# STERLING RANCH ROAD & BRIARGATE PARKWAY SEGMENT 2 STREET PLANS

## STREET IMPROVEMENT PLANS

DECEMBER 2022  
PCD FILING NO.: CDR221

**NOTES & DETAILS**

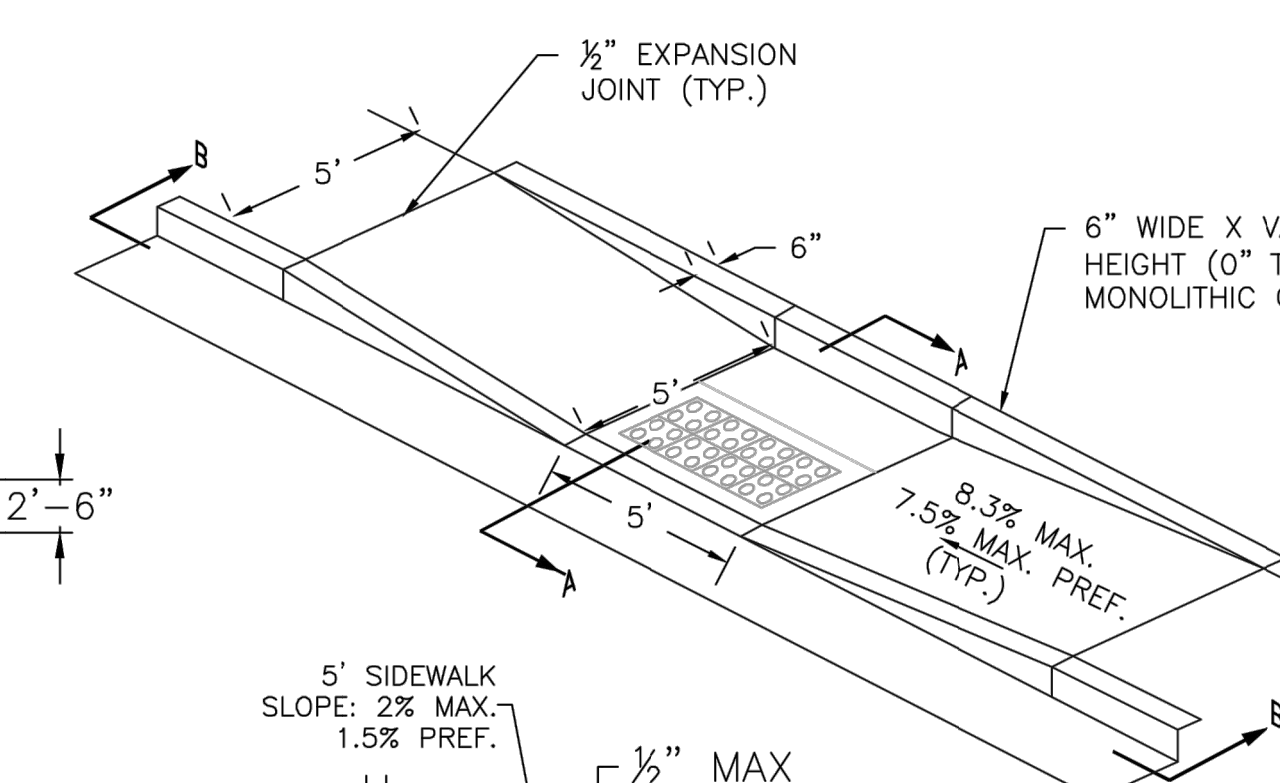
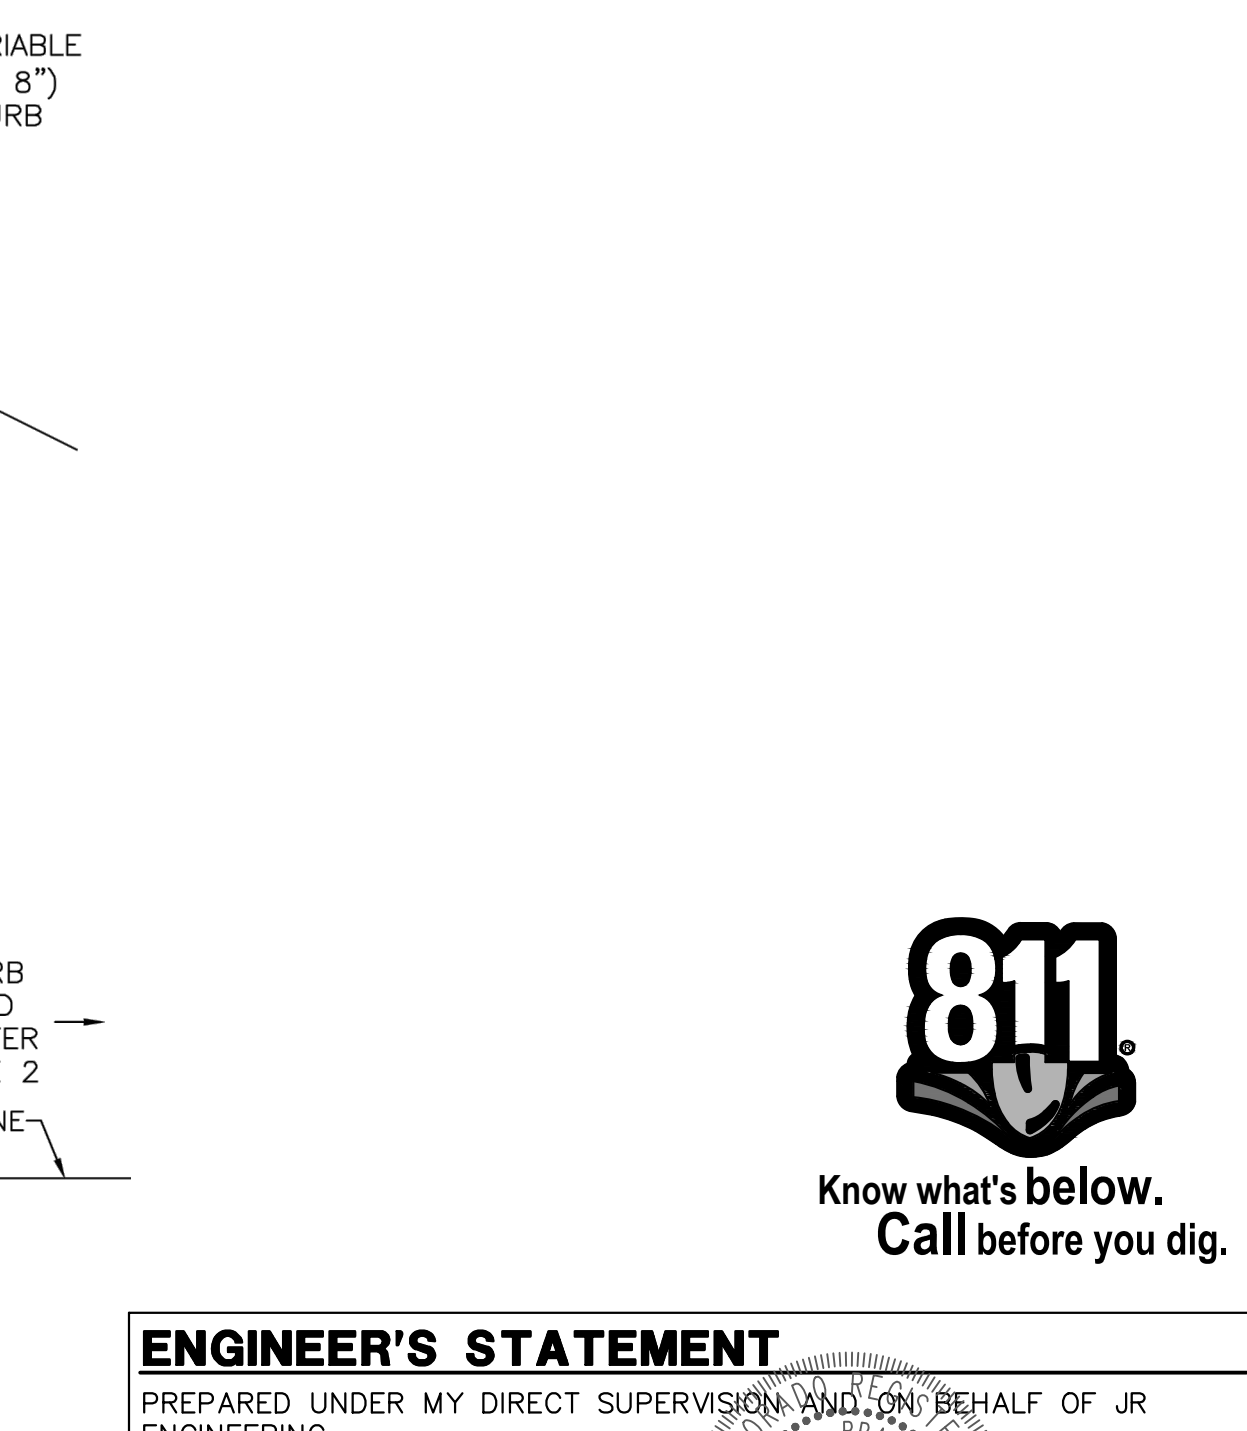
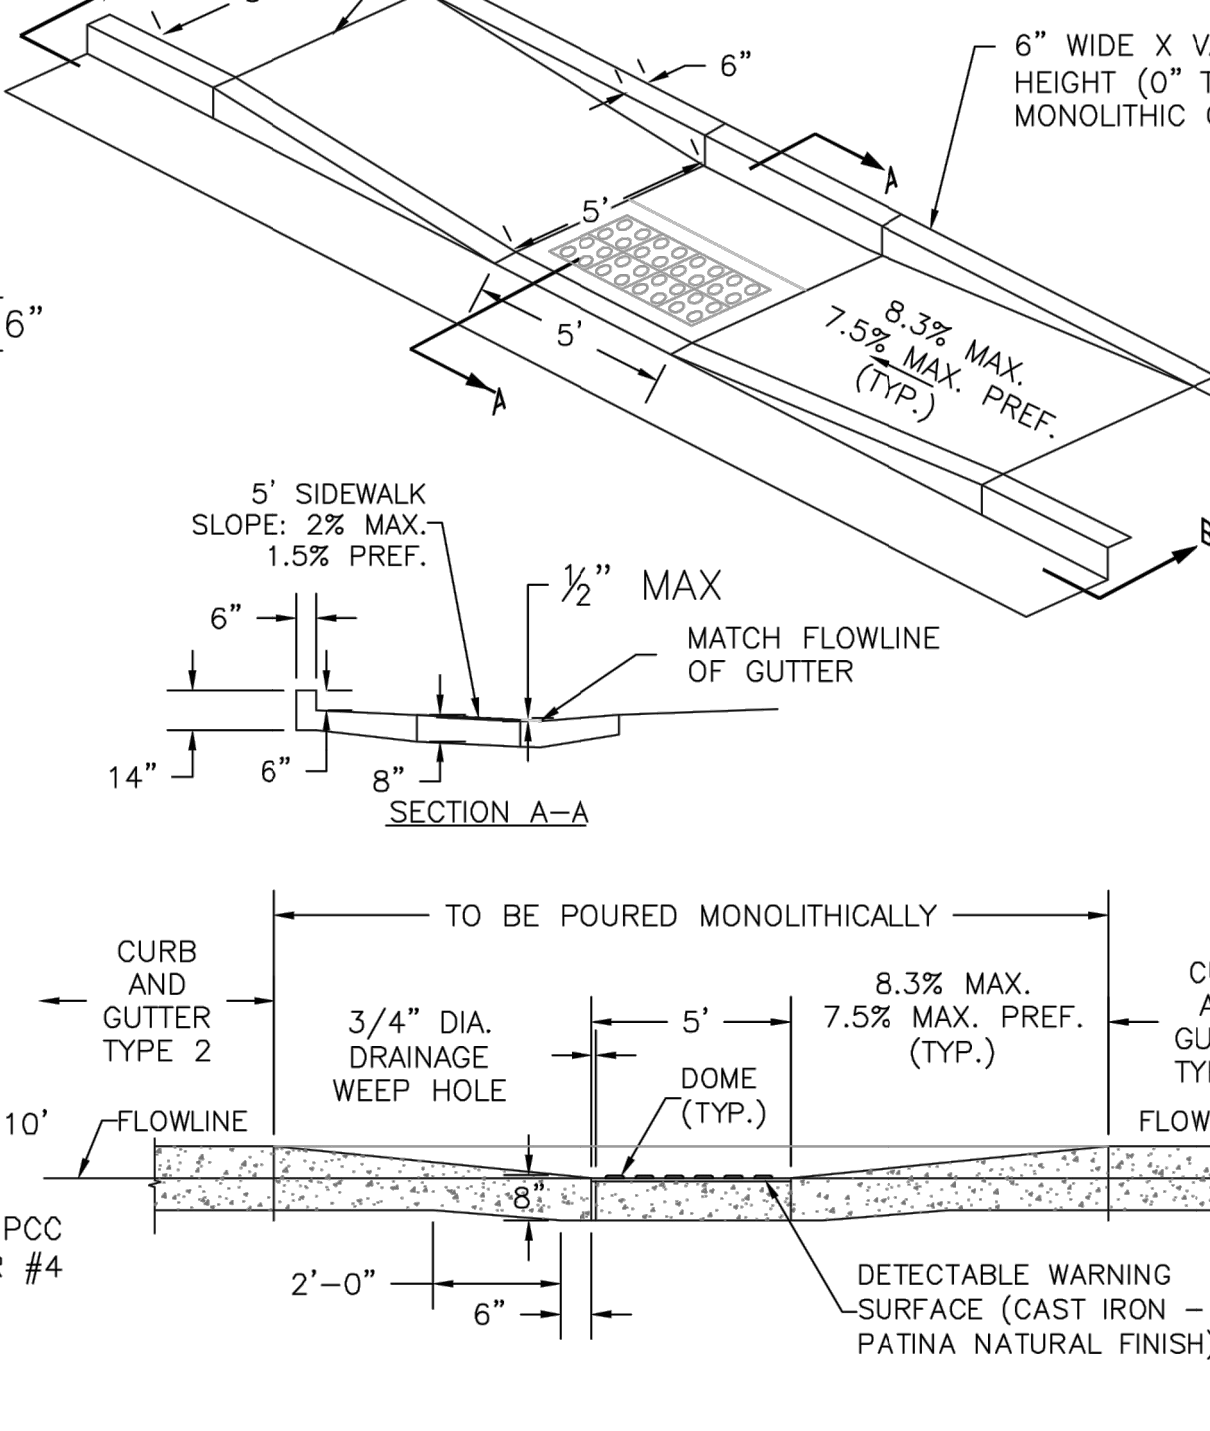
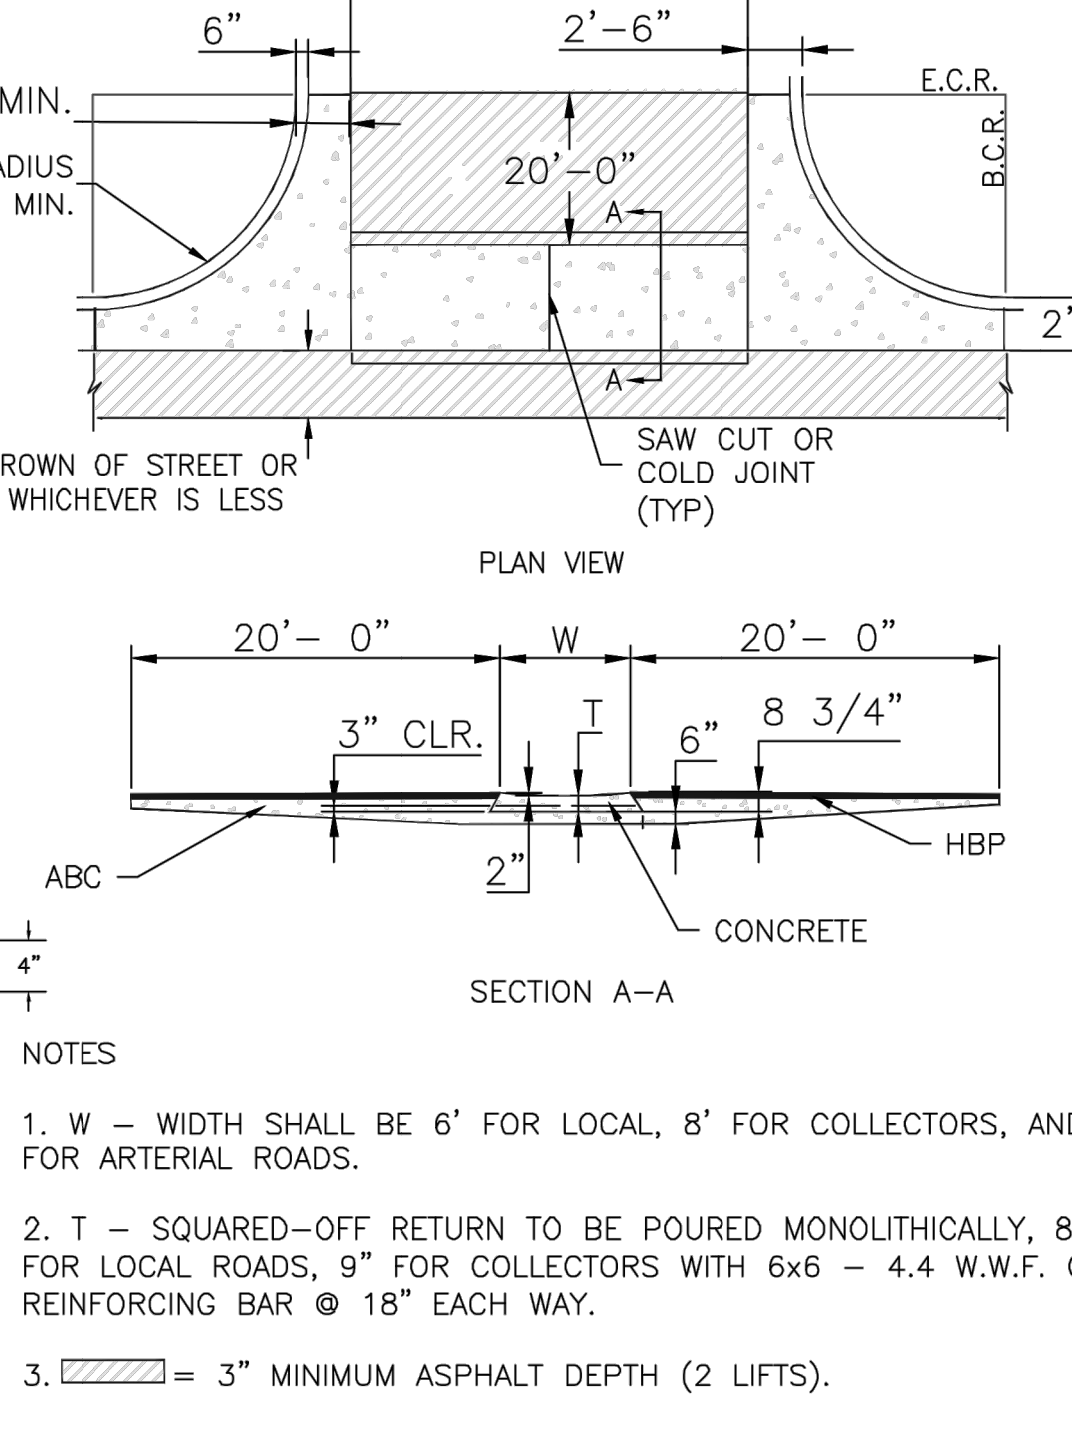
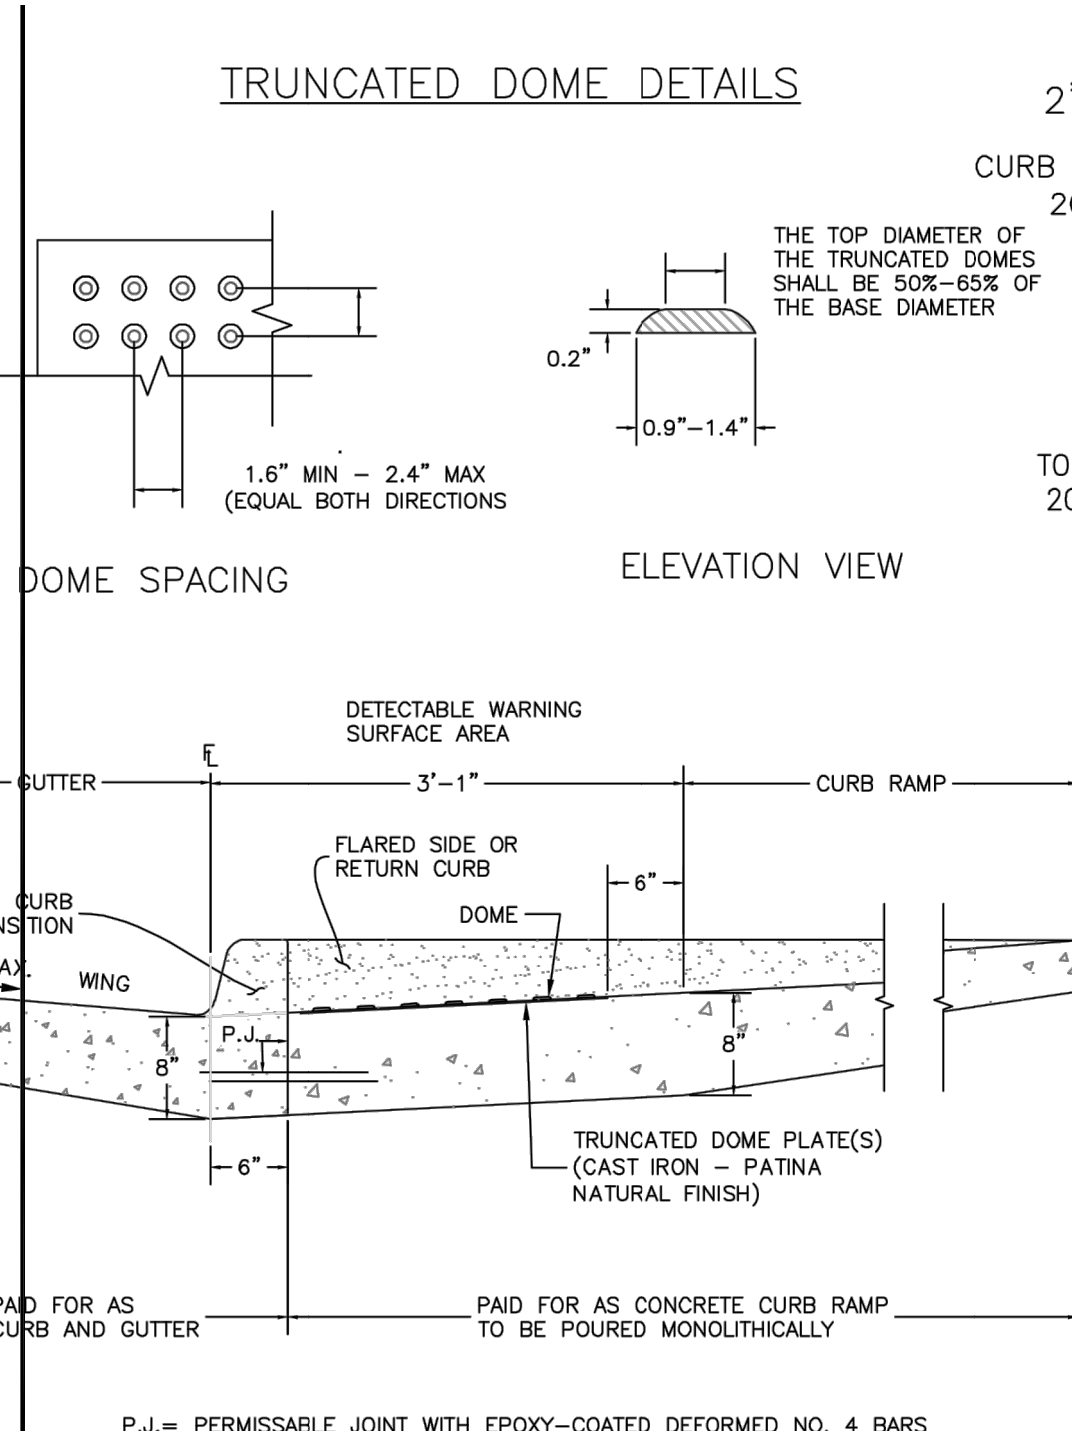
Include missing detail
